ASSESSMENT REPORT

Printing Warehouse and Distribution Facility Erskine Park Penrith
MP 08 0016 MOD 3

Figure 3: Approved (top) and proposed (bottom) office/warehouse layout

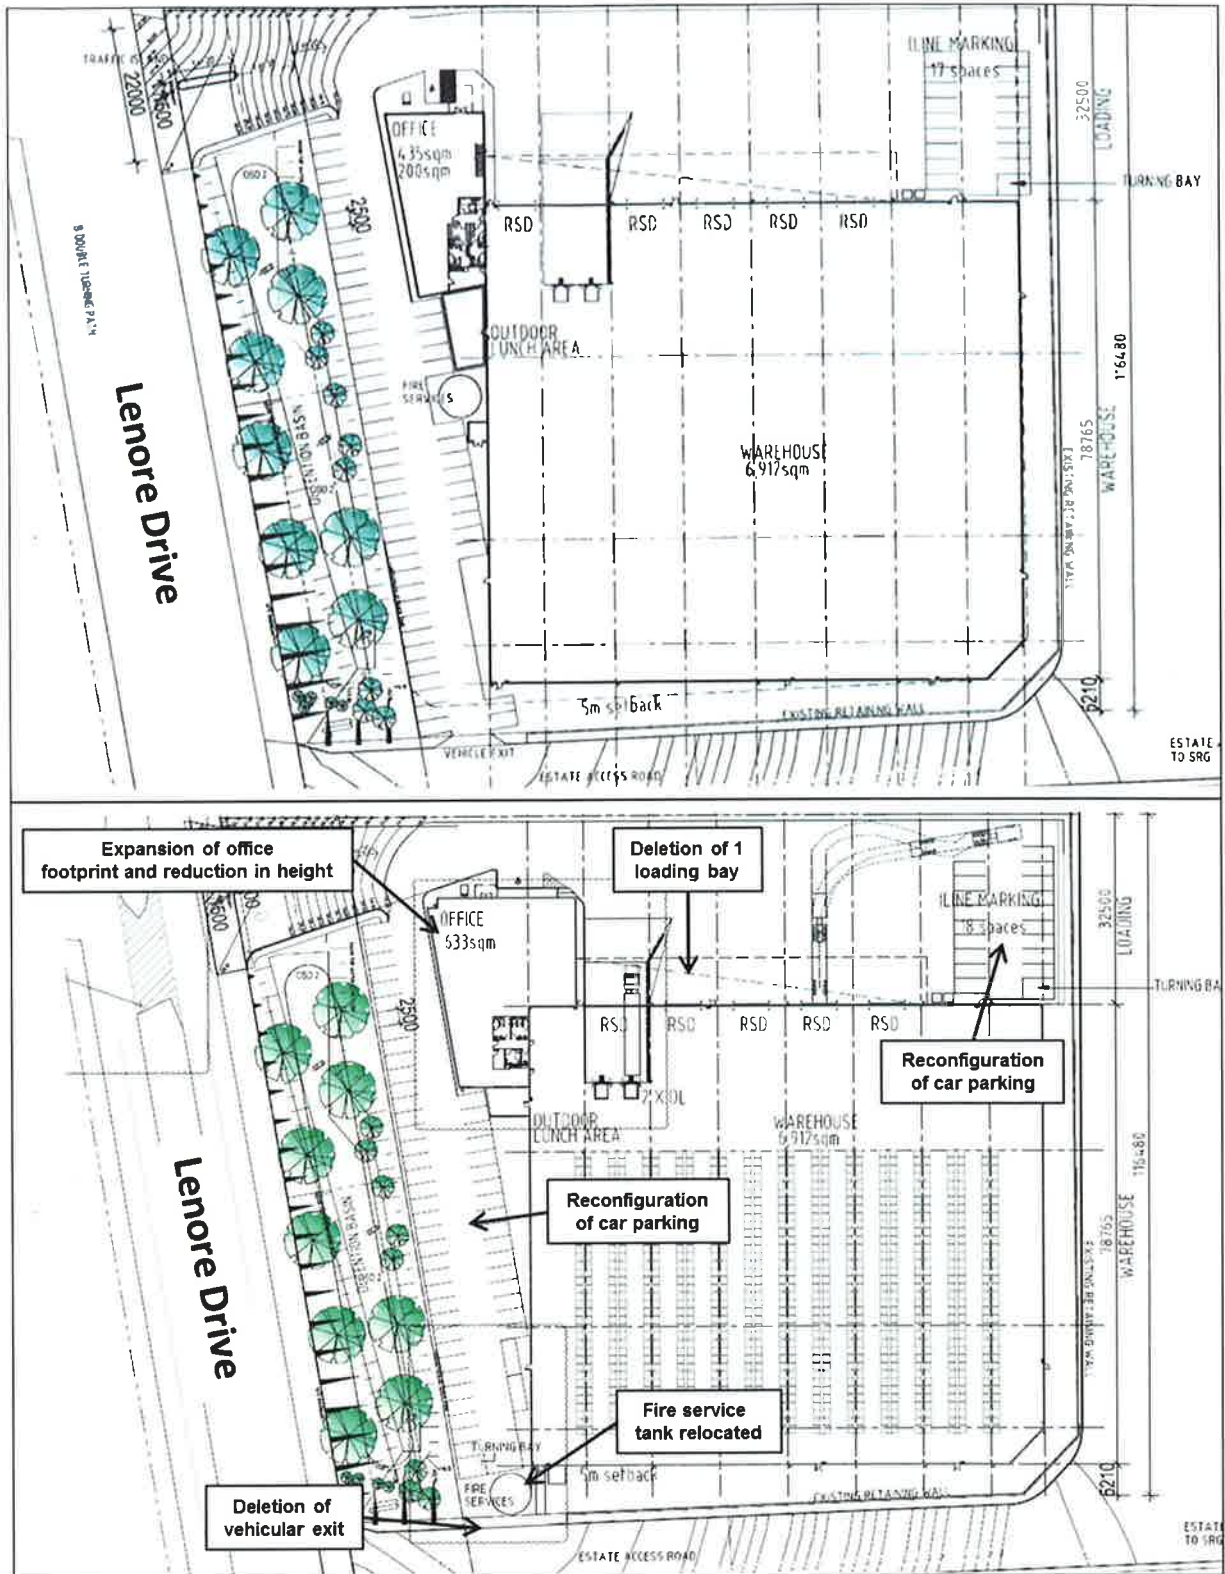
- the prominence of the office building has been reduced in scale and in architectural merit;
- the sprinkler tank should be relocated away from publicly visible areas and/or be integrated into the building;
- the large southern and eastern walls of the warehouse should be architecturally broken down; and
- front fencing should be located behind the landscape setback and not along the front boundary, should be 2.1 metres in height and of an open nature.

The proposal seeks approval to reduce the size of the office building by 2.7 metres, (from two to one storeys / from 7.5 to 4.8 metres), enlargement of its footprint and associated amendments to the design of its facades.

Council considers the presentation of the office a key aspect of the development and is concerned that the proposed modification lessens its architectural merit and that the reduced scale of the office does not minimise the perceived scale of the overall development.

The Department considers that reducing the height of the office building from two to one storey is acceptable as:

- the office building projects between 12 to 20 metres forward of the Lenore Drive warehouse frontage and would continue to have a sufficiently strong visual presence;
- there are other sites within the Erskine Park industrial precinct that contain single storey offices attached to large warehouses and therefore this built form relationship is not uncommon in the locality;
- at 4.8 metres the proposed office building is taller than a standard single storey development, which ensures that it will provide an appropriate step / transition to the warehouse component of the development; and
- the Department considers, due to its size and dominance, the presentation of the warehouse (rather than the office) is the critical visual consideration from an urban design perspective. The warehouse design is considered appropriate and sufficiently articulated as discussed within the following section.

The Department acknowledges that the proposed architectural design of the office building is less engaging than the approved office building. However, the Department considers that on balance the proposed design is acceptable for the following reasons:

- the key Lenore Drive elevation has been articulated through the use of windows and coloured panels;
- the coloured panels pick up on the colour scheme and rectilinear patterning of the warehouse building, which ensures that the office and the warehouse are read as a unified development;
- the use of precast concrete panelling (for the office component) within the Erskine Park precinct is not uncommon and is likely to be robust in terms of weathering and maintenance;
- the approved landscaping includes crowning trees which, when mature, will provide for a appropriate level of screening to the site.

In light of the above assessment the Department concludes that the reduced height of the office building and the associated revised architectural treatment is acceptable and is generally in keeping with the Industrial character of the area.
